# UNITED STATES PATENT AND TRADEMARK OFFICE

10/563,039

<b>Office Action Summary</b>	<b>Application No.</b> 10/563,039	<b>Applicant(s)</b> SMOLAREK ET AL.	
	<b>Examiner</b> ROBERTA DELISLE	<b>Art Unit</b> 3677

## DETAILED ACTION

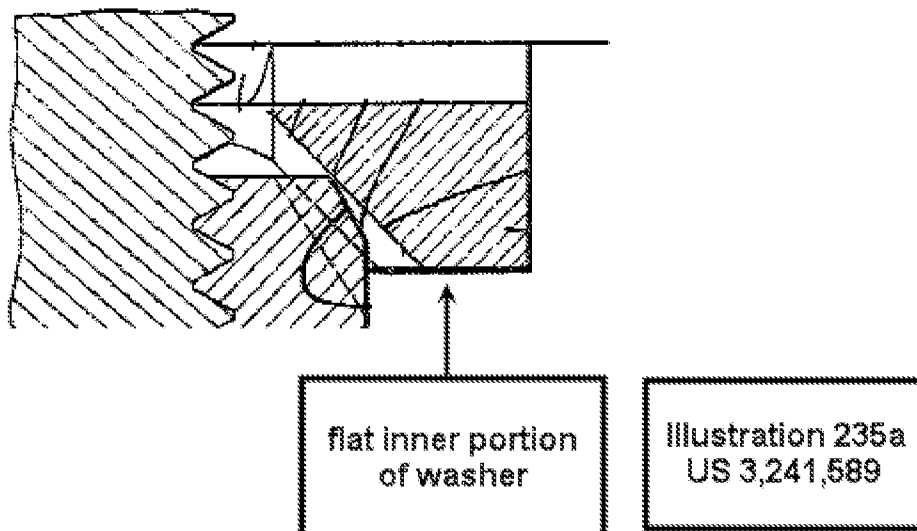
**Regarding Claim 232, Enders discloses:  
Reference figures 1-10, for example**

(New) A fastener assembly comprising a washer and a fastening element (Abstract), the fastening element (14) having an abutting face (14B) for transferring force to the washer

(13), the fastening element (14) having a periphery about the abutting face (14B), the periphery being angled (figure 7) relative to the abutting face (14B) on the fastening element (14), the washer (13) having a first face (13B) for contact with the fastening element (14), the first face (13B) having an inner portion (figure 7) for contact with the abutting face (14B) and a sloped outer portion (figure 7) about the inner portion (figure 7), wherein the sloped outer portion (figure 7) is arranged to engage with the periphery of the fastening element (14)

(New) A fastener assembly as claimed in claim 232, wherein the inner portion (figure 7) of the first face (13B) of the washer is flat (See Illustration 235a below)

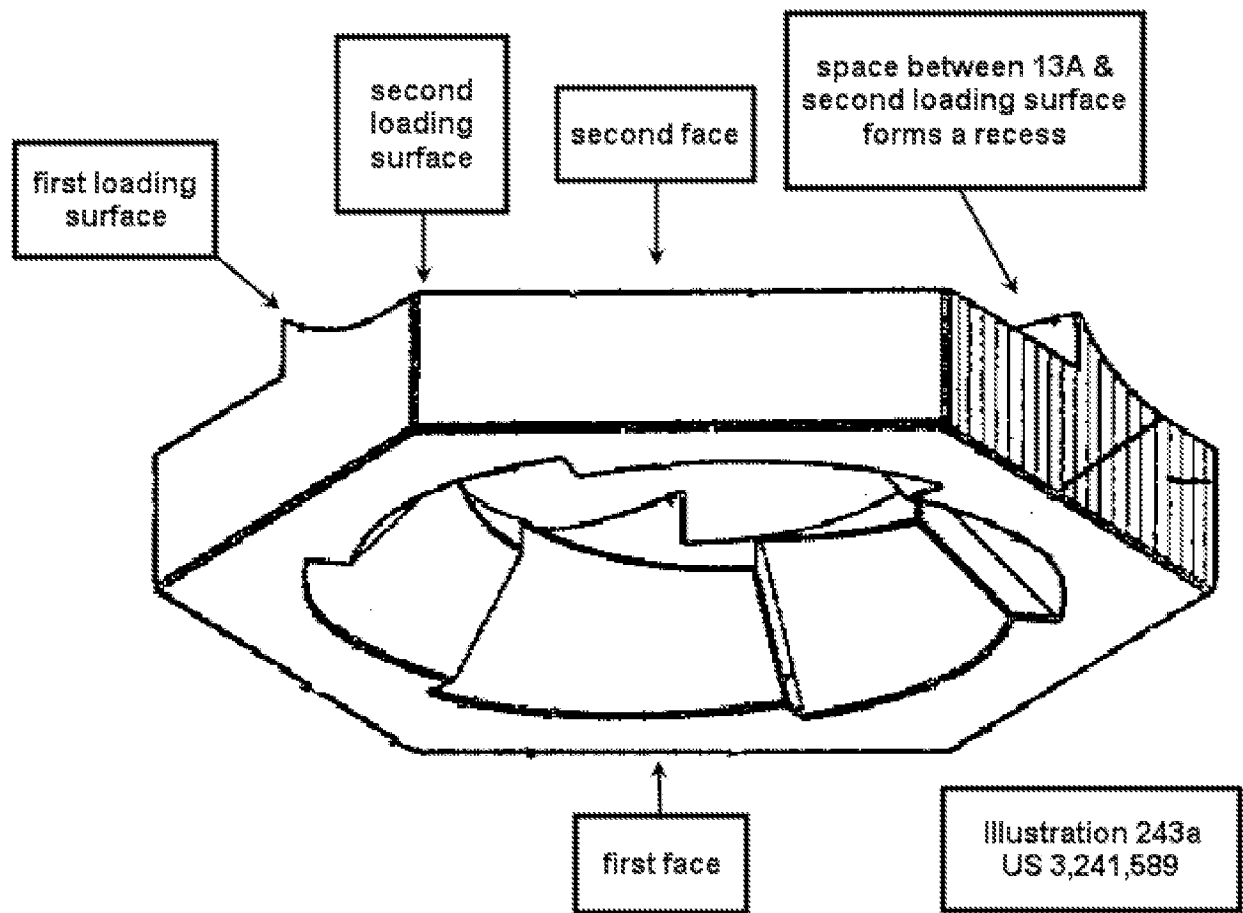
(New) A fastener assembly as claimed in claim 232, wherein the inner portion (figure 7) of the first face (13B) of the washer is annular (figure 7)

(New) A washer as claimed in claim 245, wherein the inner portion (figure 7) of the first face (13B) of the washer is flat (See Illustration 235a in Claim 235)

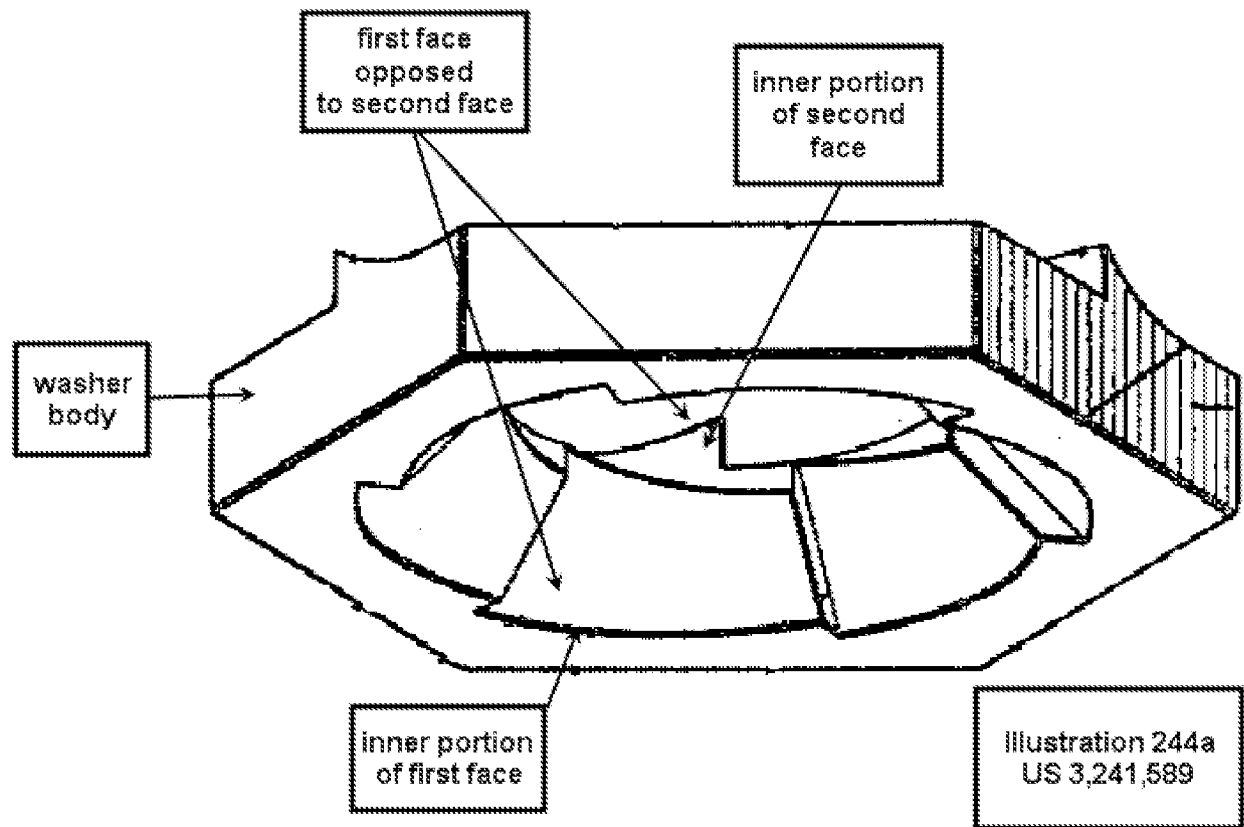
(New) A fastener assembly as claimed in claim 242, wherein the washer (13) has a second face (13A) opposed to the first face (13B), the second face (13A) having a first loading surface and a second loading surface, the first and second loading surfaces being separated by a recess (See Illustration 243a in Claim 243), whereby the washer (13) is arranged to transfer load only through the first loading surface (13) when loaded up to a first loading limit, and is arranged to transfer load through both first and second loading surfaces beyond the first loading limit

(New) A washer as claimed in claim 251, wherein the washer (13) has a second face opposed to the first face (13B), the second face having a first loading surface and a second loading surface (See Illustration 243a in Claim 243), the first and second loading surfaces being separated by a recess, whereby the washer (13) is arranged to transfer load only through the first loading surface when loaded up to a first loading limit, and is arranged to transfer load through both first and second loading surfaces beyond the first loading limit.
